Date: 11 March 2019  
Ref: 1837.DA7.312.001  
Your Ref: SSD7036

## ***APPLICATION TO MODIFY DEVELOPMENT CONSENT – CORAKI QUARRY***

The proposed modification seeks to amend the approved plan (refer Attachment 1 – Approved Plan) to reflect the as-constructed location of the processing plant (refer Attachment 2 – Amended Plan). No other changes to the development are proposed.

*Attachment 2*  
*Amended Plan*

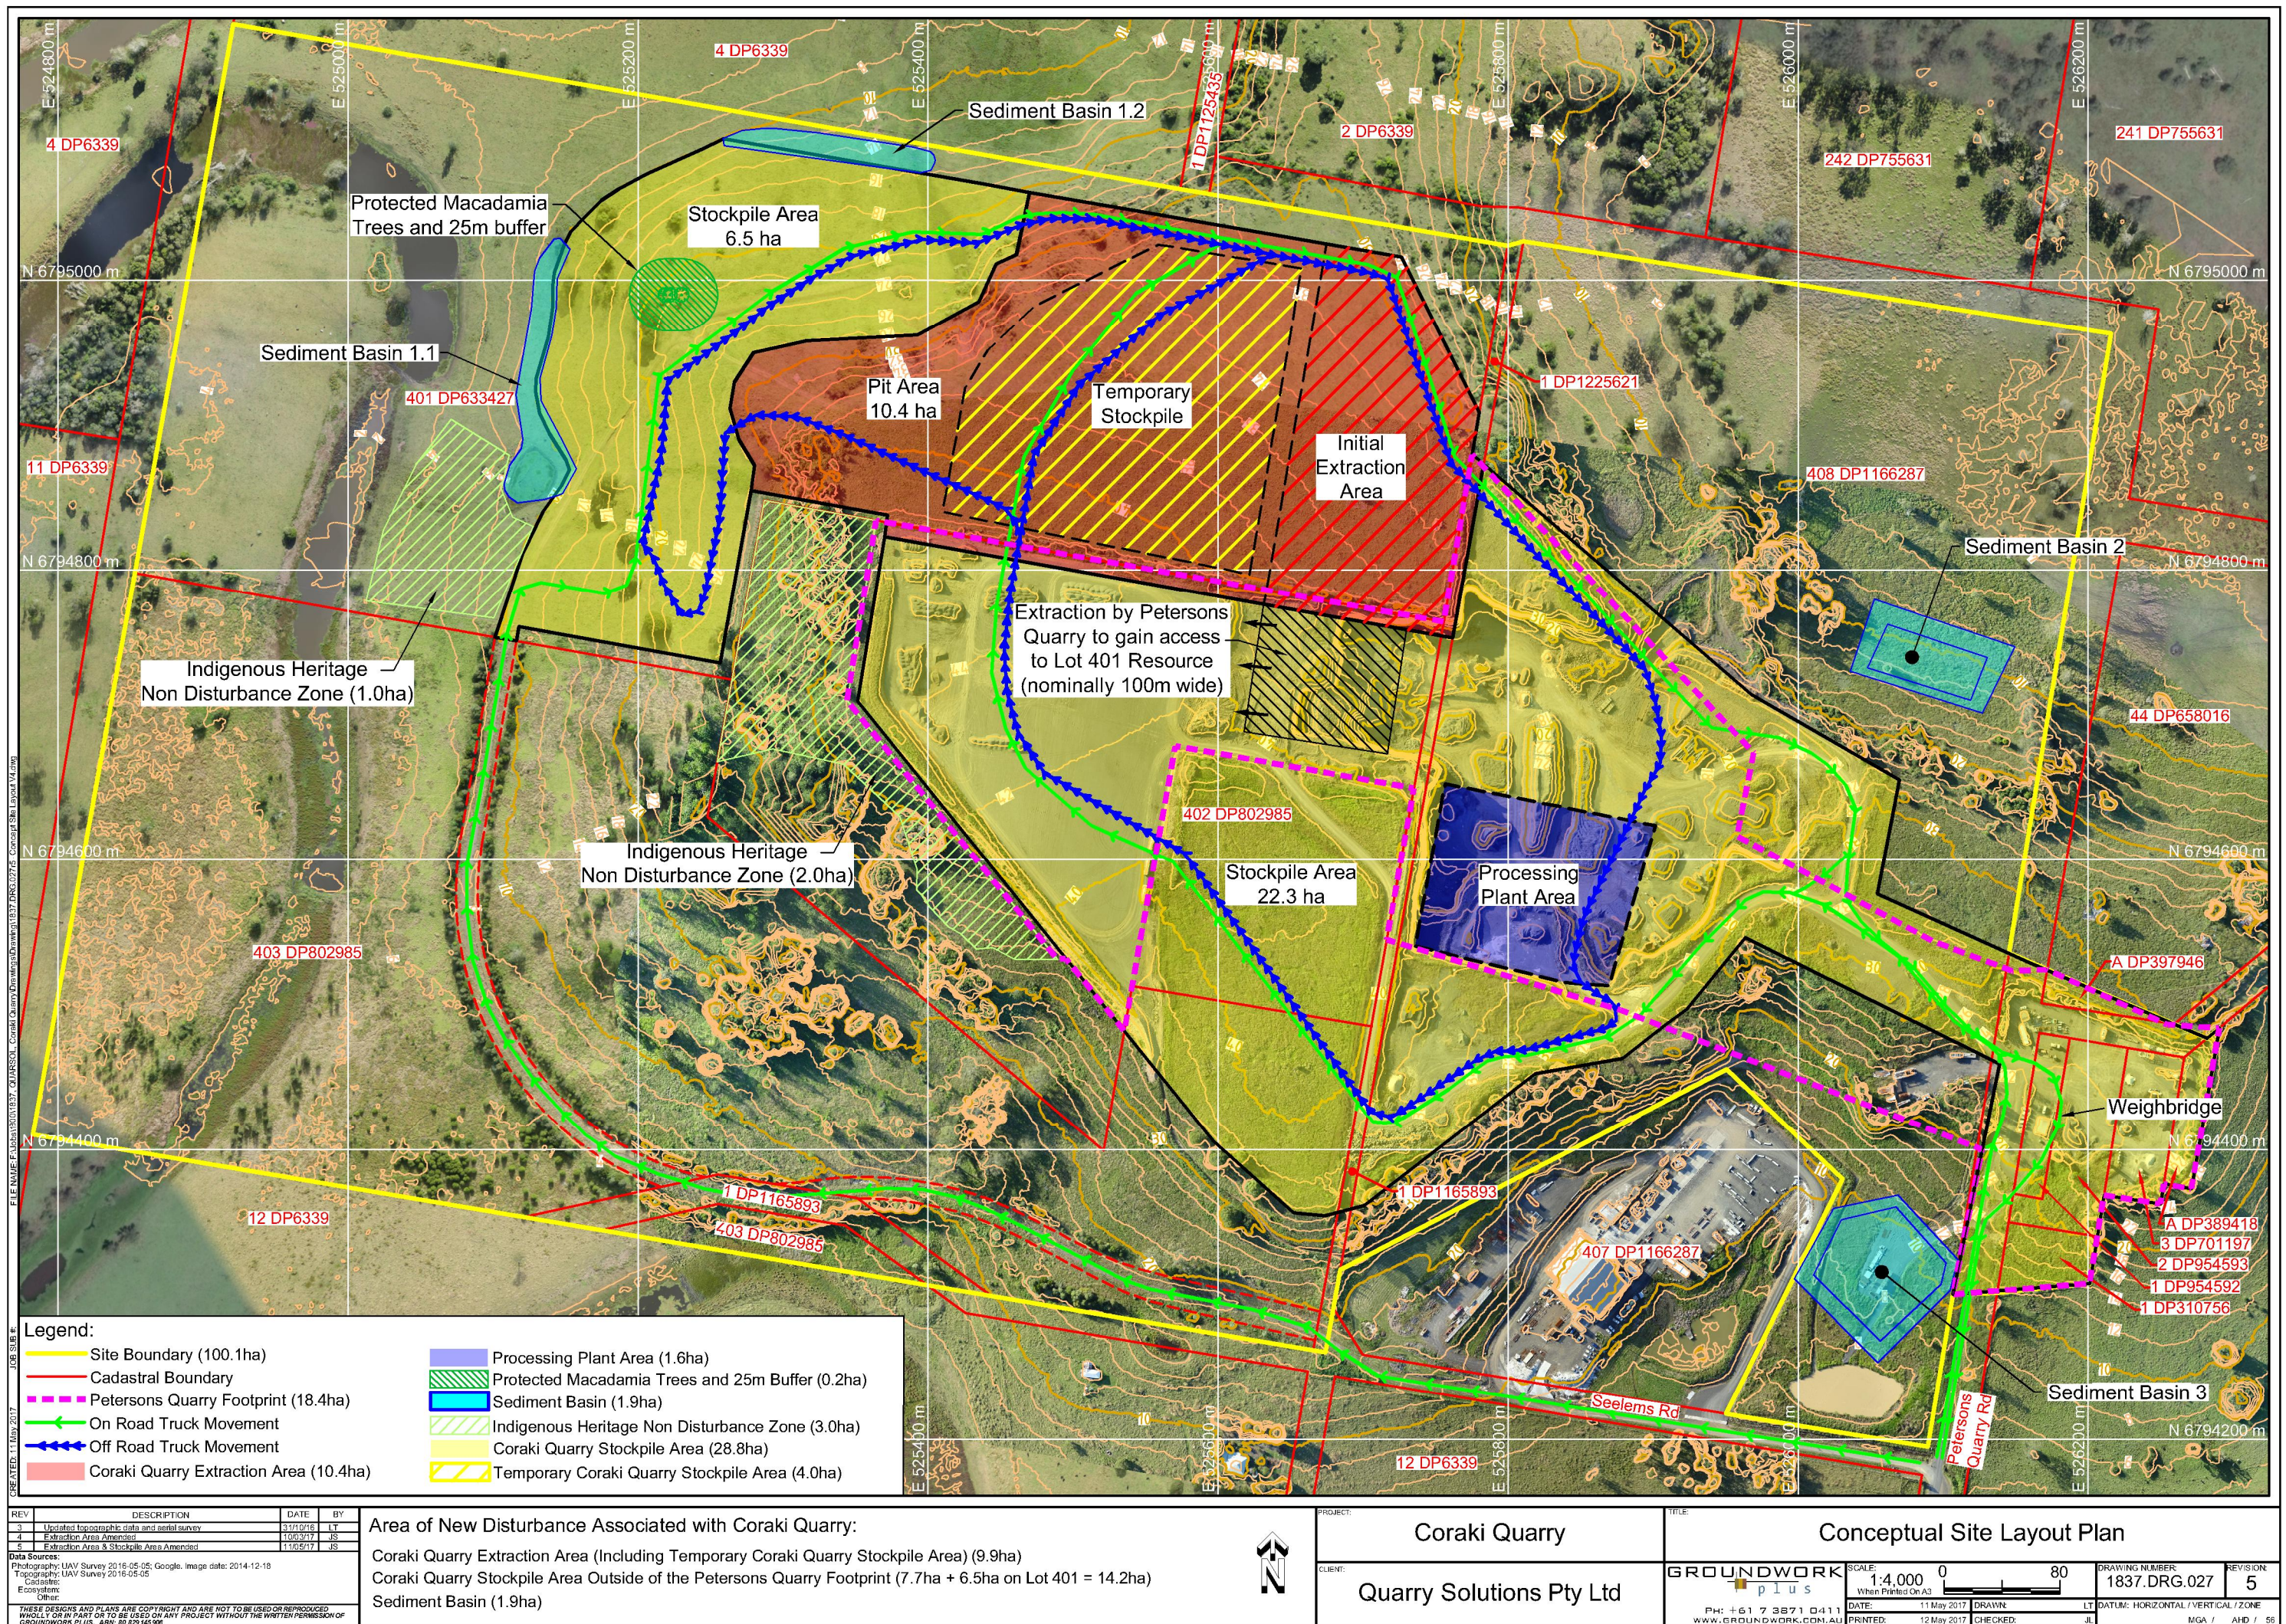
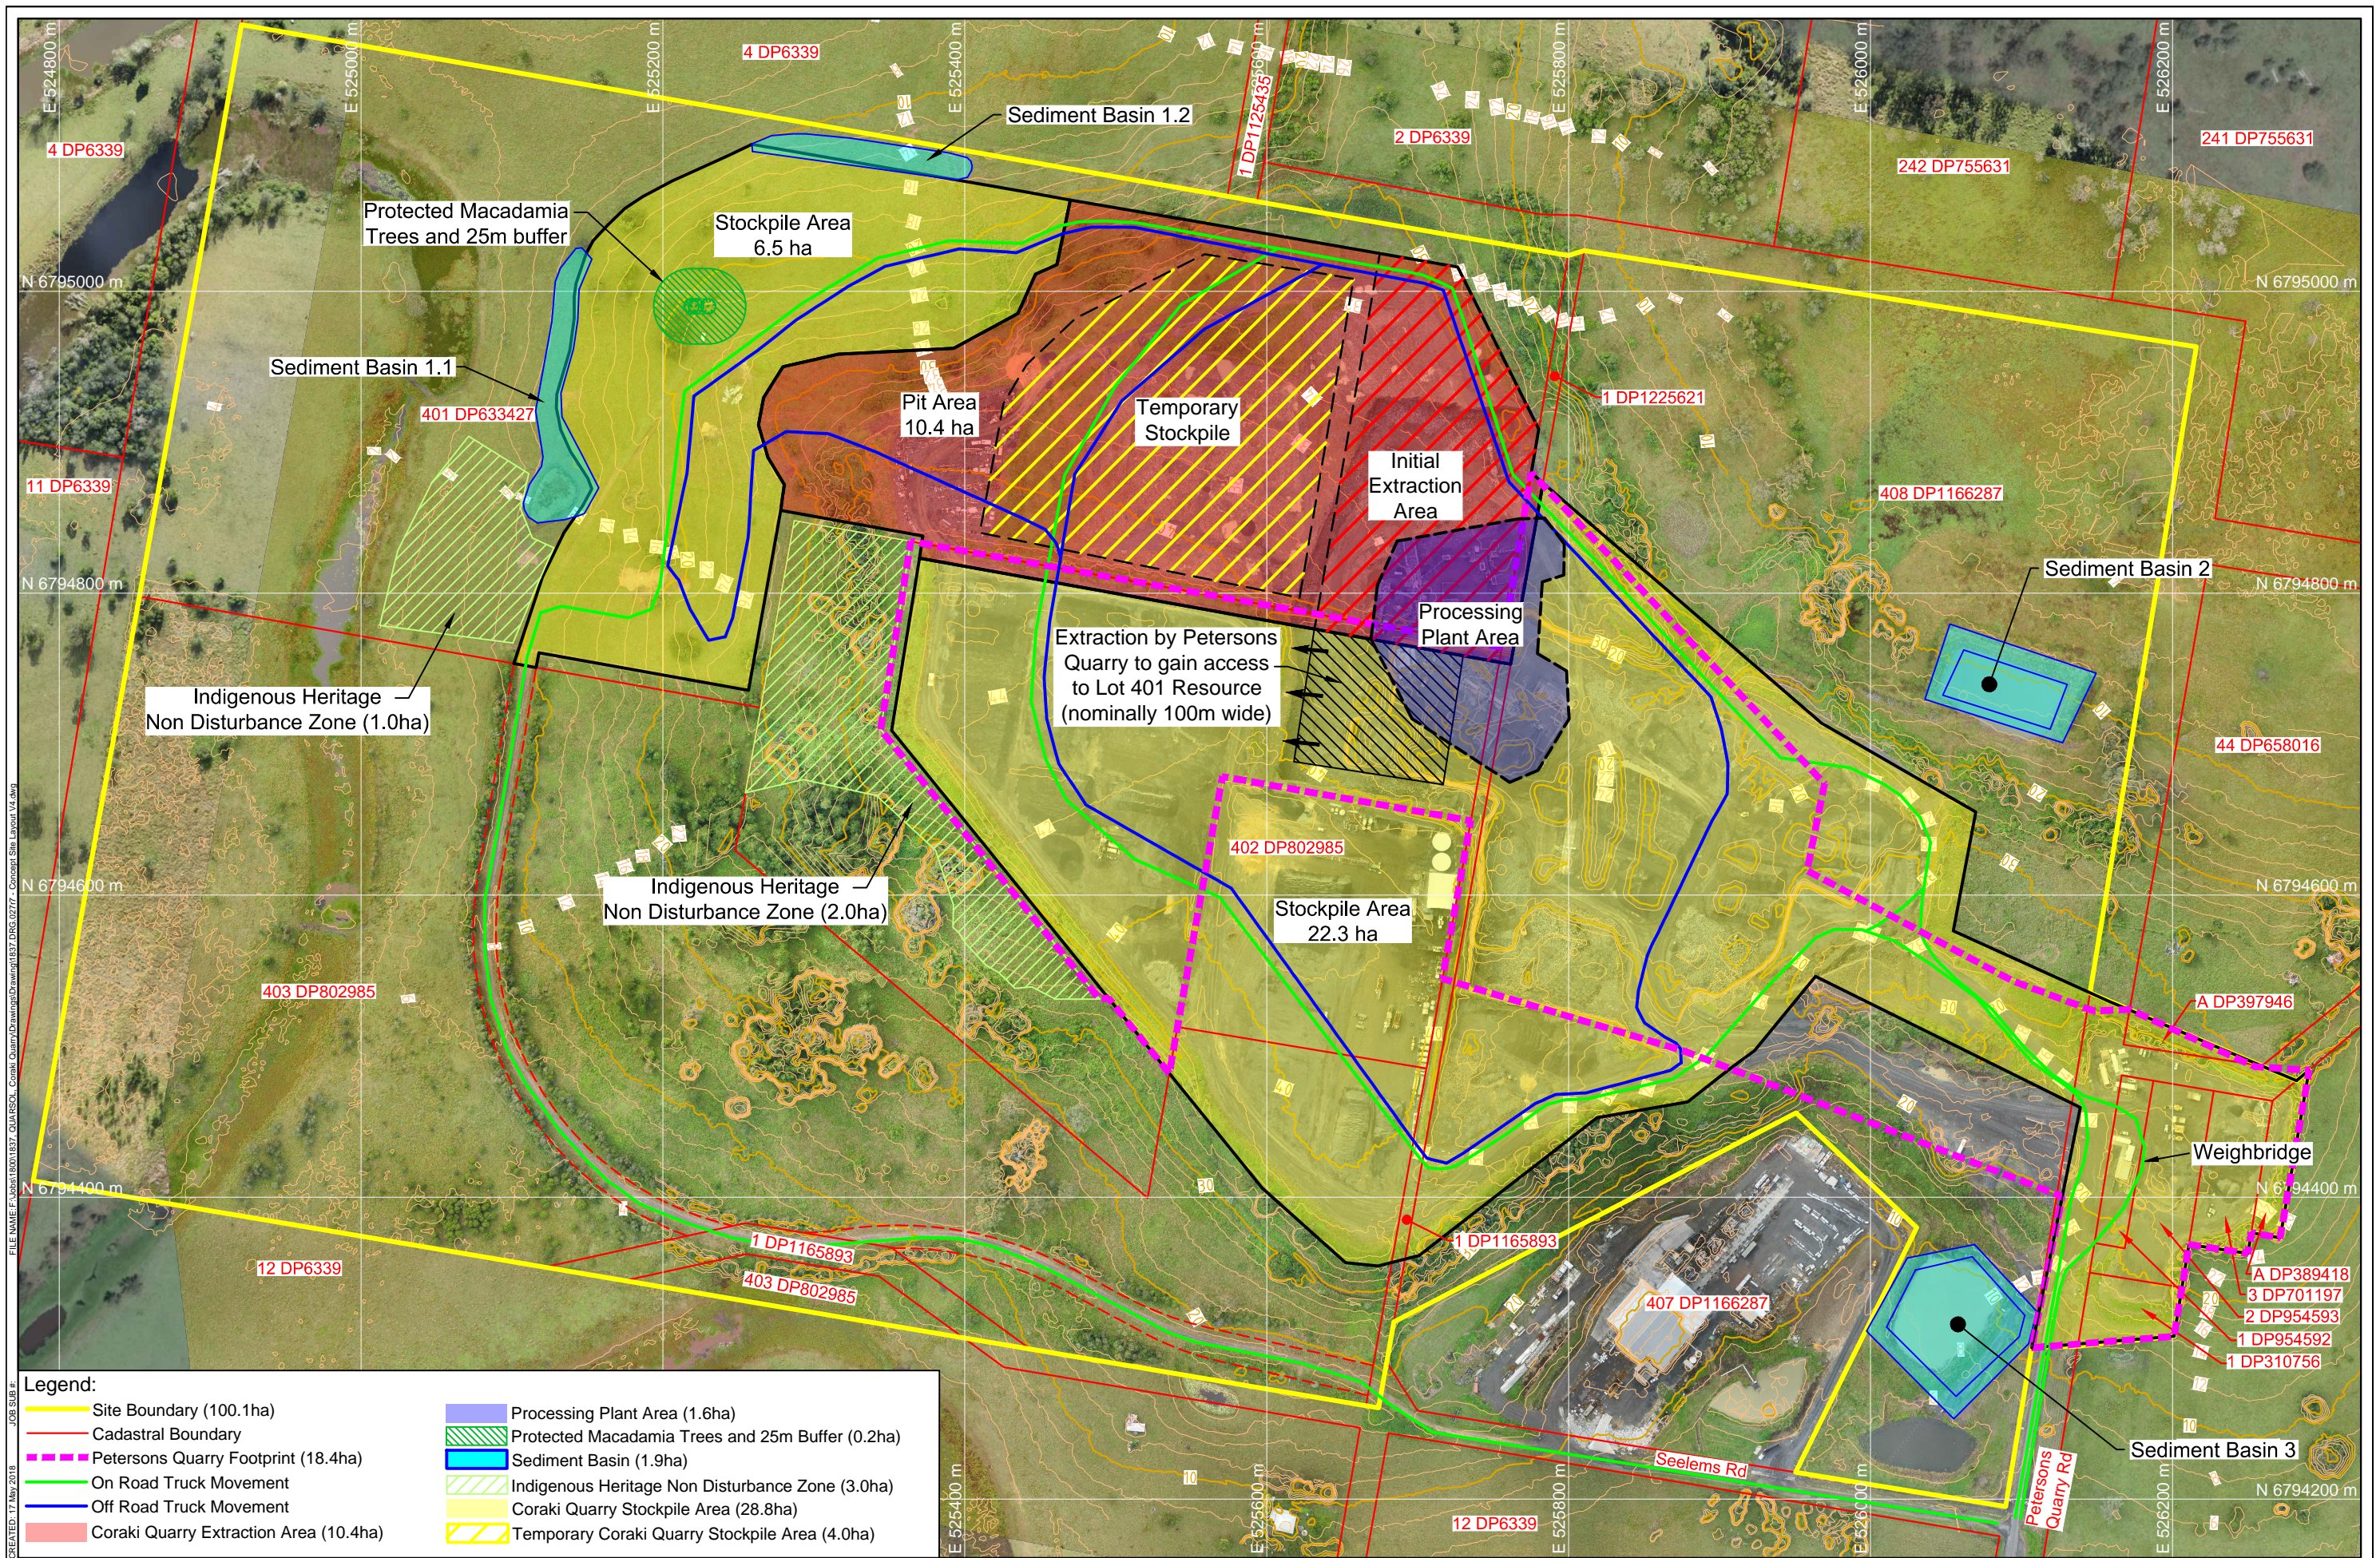
The processing plant has been constructed outside the approved area but inside the approved extraction and stockpiling areas. The as-constructed location of the processing plant does not increase the total area of disturbance of the project. The as-constructed location of the processing plant was chosen by the operator for improved operational efficiencies compared to the originally approved area. The improvements include but are not limited to:

1. reduced haul distance reducing total fuel burn and greenhouse gas emissions; and
2. access to processed material from three sides of the plant rather than two.
